Model	Power Supply Unit for N220 Savin Power Supply Unit for 9180, Nashua IF3018, infotec Power Supply Unit 9118)	Volt/Hz	Date of Modification	Serial Number
Modified Article	Parts Catalog			
Reason for Modification	Parts catalog correction

Model	Power Supply Unit for N220 (Ricoh Power Supply Unit Type A, Savin Power Supply Unit for 9180, Nashua IF3018, infotec Power Supply Unit 9118)	Volt/Hz	Date of Modification	Serial Number
Modified Article	Optional DC Drive Board			
Reason for Modification	To increase reliability of the optional dc drive board

DETAILS OF MODIFICATION

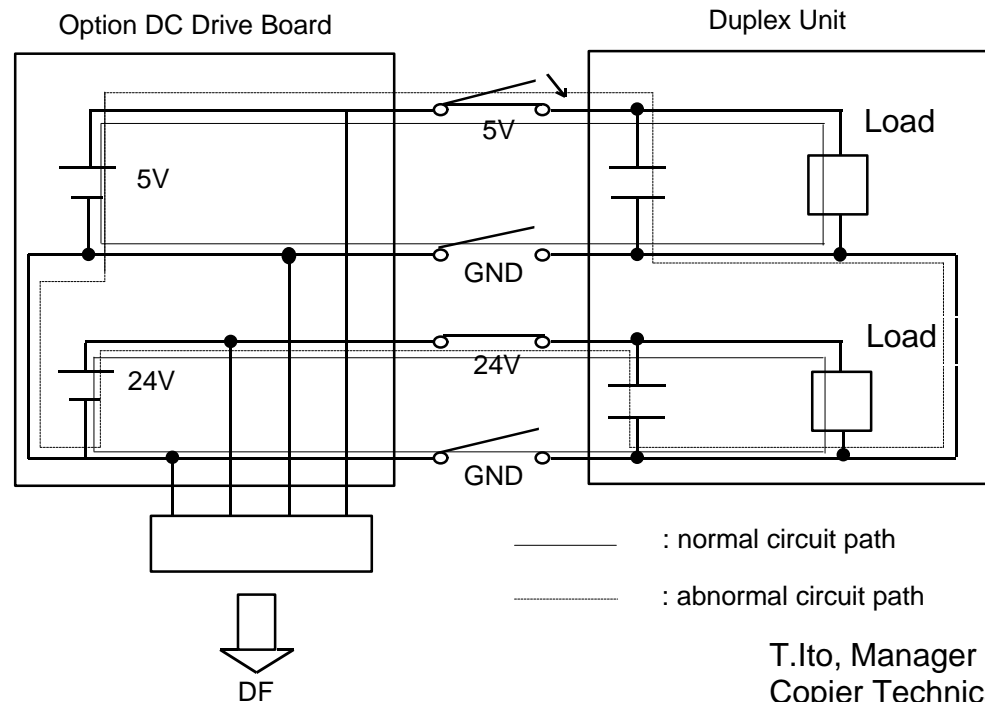
Electrical malfunction of the DF due to electrical noise was found at the factory. When the duplex unit is pulled out and in, poor connection may occur at CN720 as shown in the following schematics. Electrical noise may then be generated on the 5V line of the optional dc drive board. The electrical noise causes an electrical malfunction on the DF. For example, a motor may stay on. The occurrence ratio is expected to be very low. To prevent the electrical malfunction, the zener diode has been removed and two diodes have been added as shown in the schematics of the modified optional dc drive board (next page).

When the duplex unit is inserted, if the following sequence occurs, the current (24V) goes through the 5V line circuit. This generates electrical noise.

When inserting the duplex unit;

- Two ground lines are not connected.
- The 24V line is connected first.
- Then, the 5V line is connected

Optional DC Drive Board Schematics

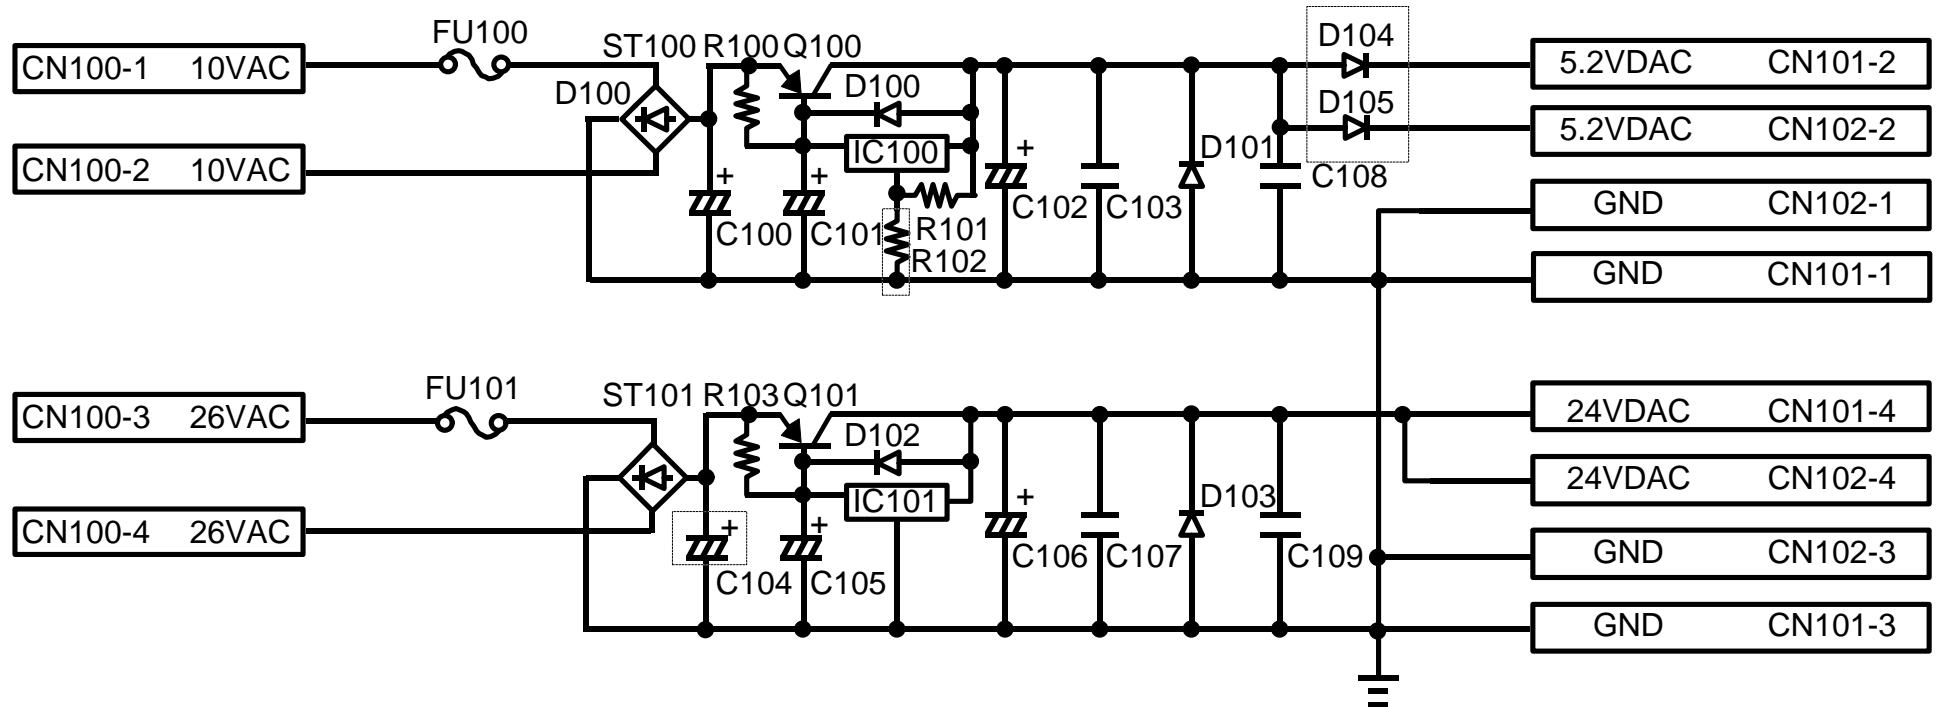
: Modified parts
